CONDITIONS OF APPROVAL:

Engineering - Final Plat Checklist

23. C. Final Plat

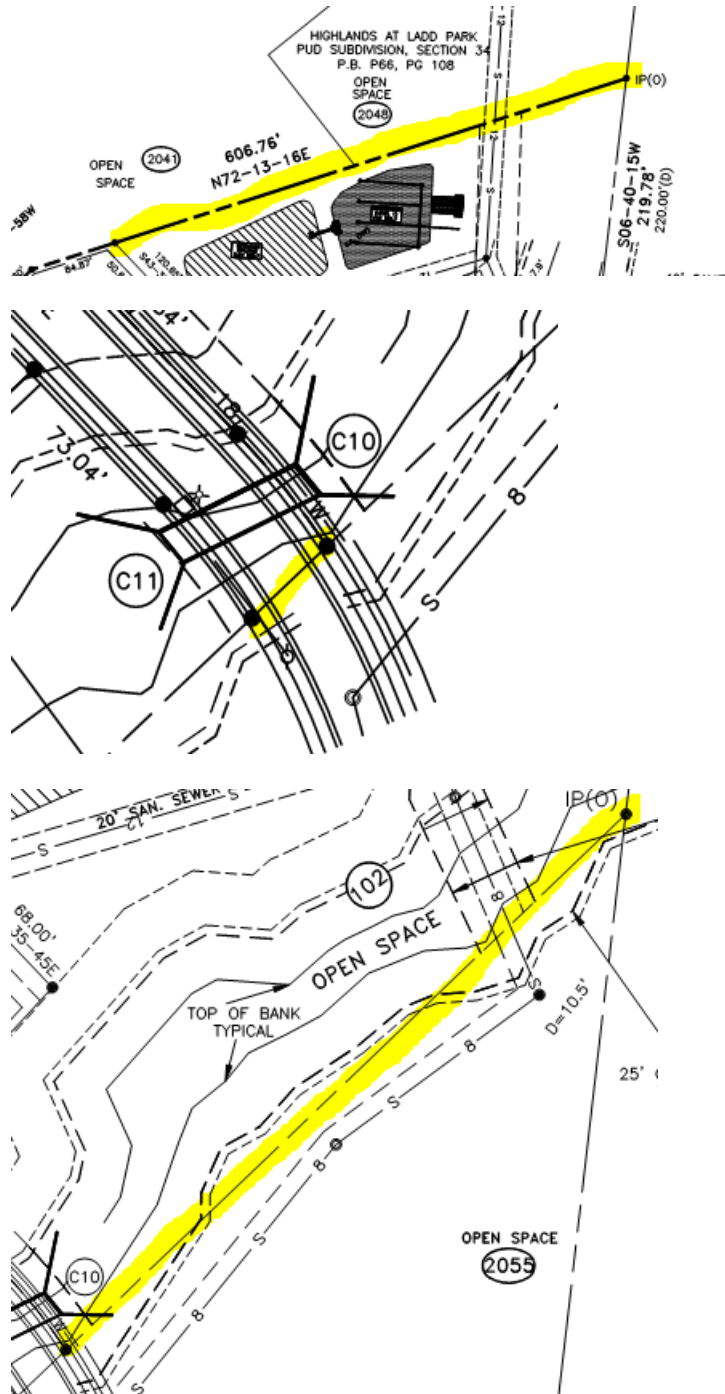
lance.fittro@franklintn.gov The previous comment has been partially addressed. Applicant shall show lengths for the property lines highlighted below:

28. Line Weight

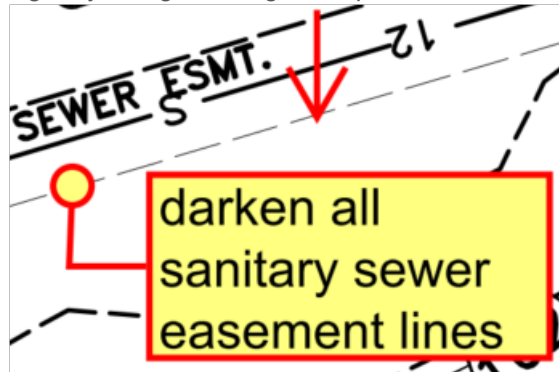
jimmy.wiseman@franklintn.gov Comment not adequately addressed.

Some line weights for sanitary sewer easement lines appear darker than others. Applicant to darken all lighter sanitary sewer easement lines to help ensure legibility during scanning and reproduction.
